**FINAL**  
**ORDNANCE AND EXPLOSIVES WASTE/  
GEOTECHNICAL CHARACTERIZATION REPORT**  
**Revision 0**  
**January 2, 2004**

**ORDNANCE AND EXPLOSIVES WASTE CHARACTERIZATION,  
TIME-CRITICAL REMOVAL ACTION,  
AND GEOTECHNICAL AND SEISMIC EVALUATIONS  
AT INSTALLATION RESTORATION SITE 2  
ALAMEDA POINT  
ALAMEDA, CALIFORNIA**

**RESPONSE TO COMMENTS**  
**DRAFT FINAL ORDNANCE AND EXPLOSIVES WASTE/**  
**GEOTECHNICAL CHARACTERIZATION REPORT**  
**DCN: FWSD-RAC-03-2899, DATED DECEMBER 29, 2003,**  
**ORDNANCE AND EXPLOSIVES WASTE CHARACTERIZATION,**  
**TIME-CRITICAL REMOVAL ACTION,**  
**AND GEOTECHNICAL AND SEISMIC EVALUATIONS**  
**AT INSTALLATION RESTORATION SITE 2,**  
**ALAMEDA POINT, ALAMEDA, CALIFORNIA**

**RESPONSE TO COMMENTS  
DRAFT ORDNANCE AND EXPLOSIVES WASTE/  
GEOTECHNICAL CHARACTERIZATION REPORT  
DCN: FWSD-RAC-02-1787, DATED JANUARY 20, 2003,  
ORDNANCE AND EXPLOSIVES WASTE CHARACTERIZATION,  
TIME-CRITICAL REMOVAL ACTION,  
AND GEOTECHNICAL AND SEISMIC EVALUATIONS  
AT INSTALLATION RESTORATION SITE 2,  
ALAMEDA POINT, ALAMEDA, CALIFORNIA**

**Figure 1-2**  
**IR SITE 2 SITE PLAN**  
**ALAMEDA, CA**  
 Southwest Division  
 Naval Facilities Engineering Command

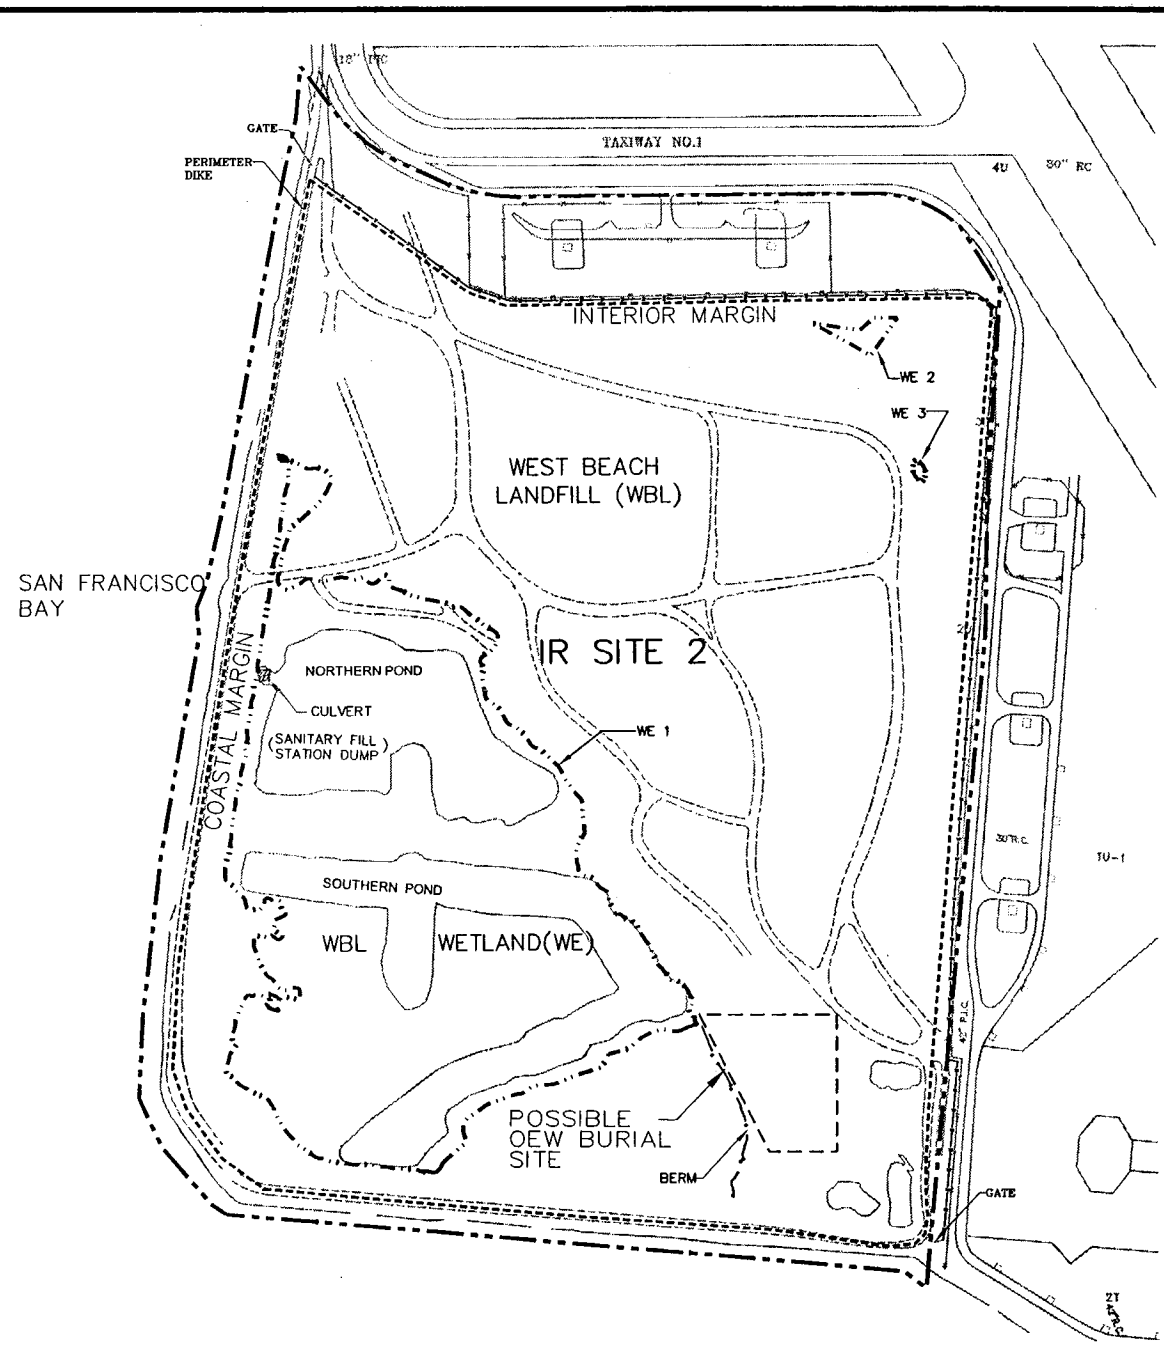
**Comment 1.** Section 2, Wetland Assessment and Site Surveys:  
Please identify in map format, the locations of all the wetland areas such as Wetlands WE1, WE2 and WE3 (see Mr. Ram Ramanujan's original comment #2, dated April 2, 2003).

**Response 1.** Comment noted. As stated in the Draft Final Ordinance and Explosives Waste/Geotechnical Characterization Report, previously wetland areas designated as WE1, WE2, and WE3 are shown in Figure 1-2, IR Site 2 Site Plan. A reference to Figure 1-2 has been added in Section 2.1. The last sentence in the first paragraph of page 2-2 has been revised as follows: "Potential jurisdictional wetlands found within the project study area are listed in Table 2-1 and shown on Figure 1-2."

Wetland areas designated as WE1, WE2, and WE3 are shown in Figure 1-2, IR Site 2 Site Plan. A reference to Figure 1-2 has been added in Section 2.1. The last sentence in the first paragraph of page 2-2 has been revised as follows: "Potential jurisdictional wetlands found within the project study area are listed in Table 2-1 and shown in Figure 1-2."

Figure 4-4  
**GEOLOGIC CROSS SECTION A-A'**

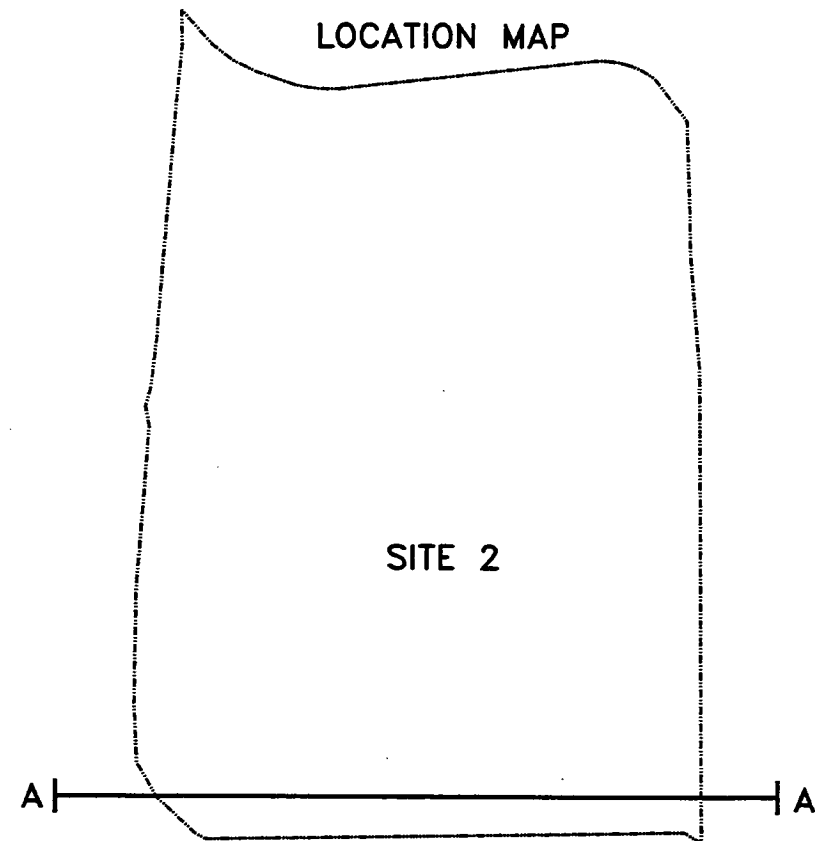
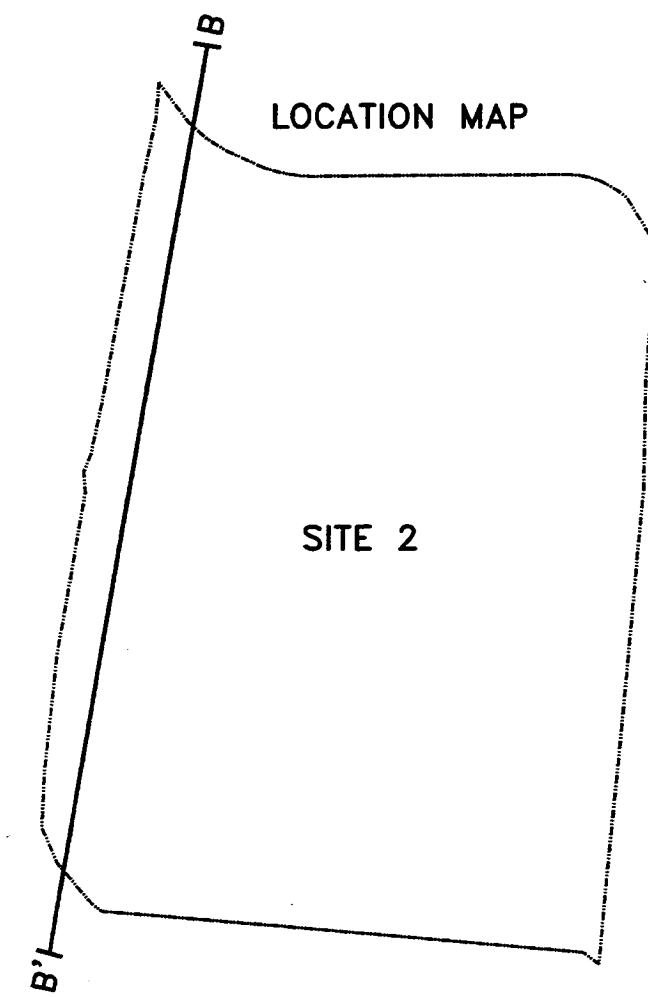
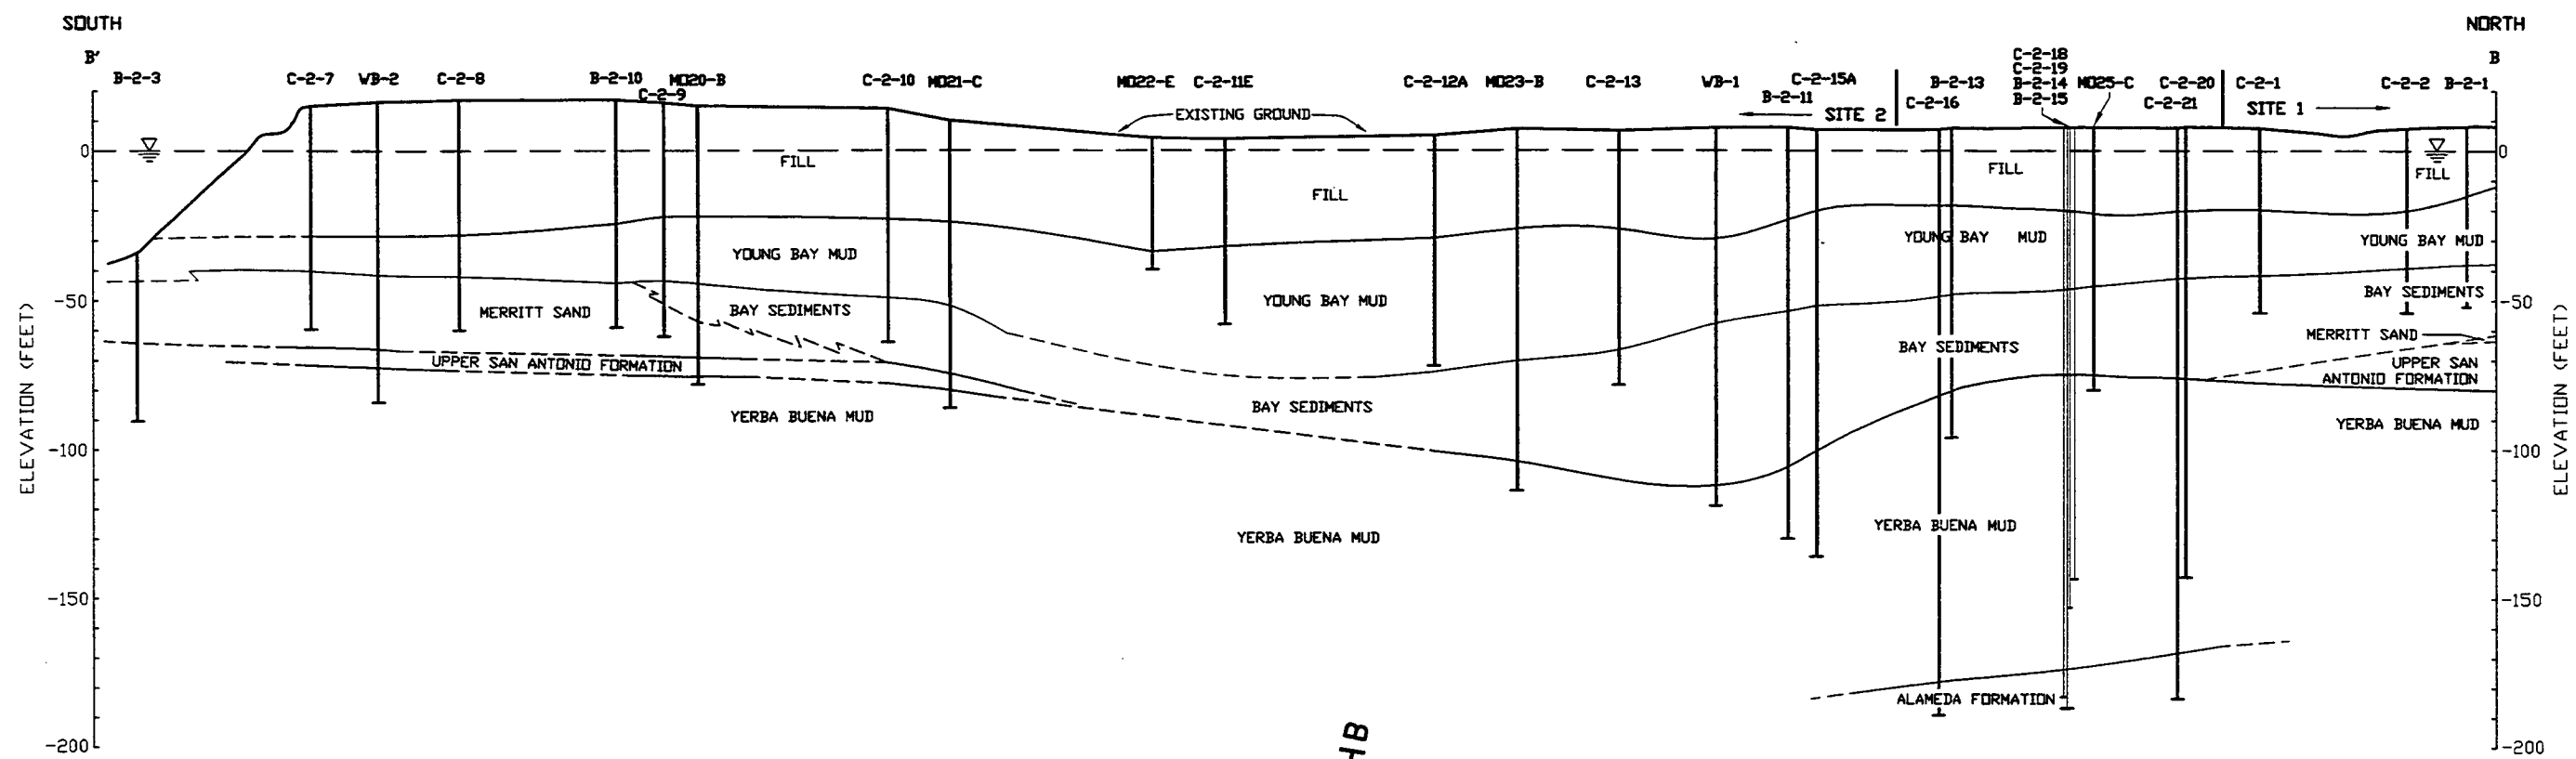
**Comment 6.** Figures 4-4 and 4-5.

The elevation of the water table will be added to Figures 4-4 and 4-5.
